UNITED STATES PATENT AND TRADEMARK OFFICE

APPLICATION NO.	FILING DATE	FIRST NAMED INVENTOR	ATTORNEY DOCKET NO.	CONFIRMATION NO.
10/031,341	01/18/2002	Philippe Dupuy	217694US2PCT	6469

Office Action Summary

DETAILED ACTION

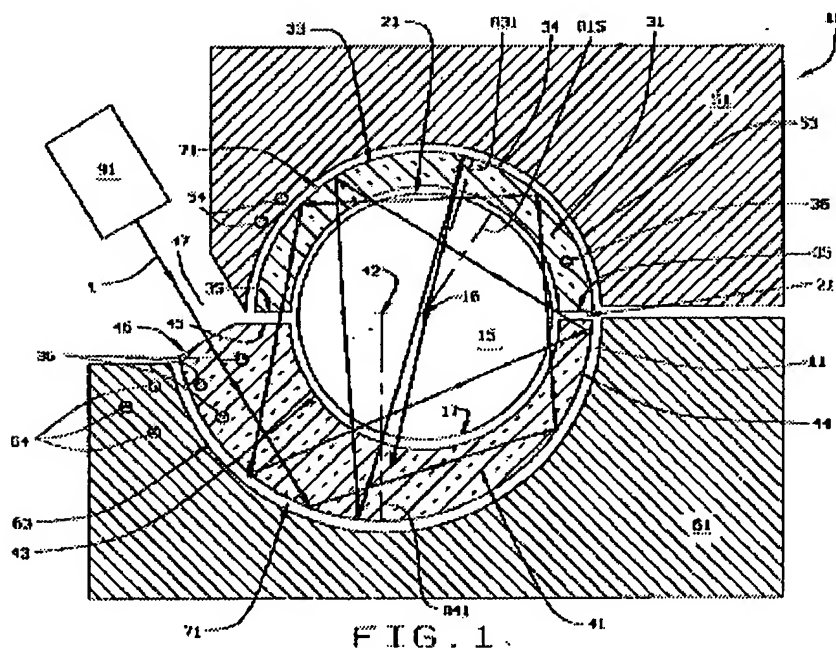
Regarding claim 14, Dube discloses an optical pumping module comprising a light amplifying medium (15), at least one light source (91) for optically pumping the amplifying medium (15) and a reflector which encircles the amplifying medium (15) and the wall of the reflector (44 and 34) is configured to reflect light from the source, wherein the reflector is partly or totally diffusive (see column 8, line 29-31) and the source (91) is orientated so as to send a beam directly stemming from this source towards the wall of the reflector so that this beam undergoes successive partly or totally diffusive reflections thereon and the amplifying medium (15) is optically pumped by the sole light reflected by the wall of the partly or totally diffusive reflector (See fig. 1 below).

Regarding claims 15-24, Dube discloses the module, wherein the amplifying medium (15) forms a cylindrical rod (See column 5, line 2-3) with a substantially circular base, the light source (91) is for transverse optical pumping of this medium (15), and the wall of the reflector forms a cylinder with generatrices parallel to an axis of the amplifying medium (See fig 1 below), the base of the cylinder formed by the wall of the reflector is selected from substantially regular polygons, ellipses (See fig 1 and fig. 6), the light source (91) is a light emitter and this light emitter is selected from a laser diode, a laser diode array, a row of laser diode arrays, a stack of laser diode arrays, and a combination of the row and the stack, the arrays being parallel to generatrices of the cylinder formed by the wall of the reflector (See column 1, line 43-55), the module comprising several blocks (see fig 1), the light source (91) is placed in a gap formed

between two adjacent blocks (See fig 1), each block comprising a planar face (see column 4, line 18-21), the light source is a light emitter (See column 1, line 49)
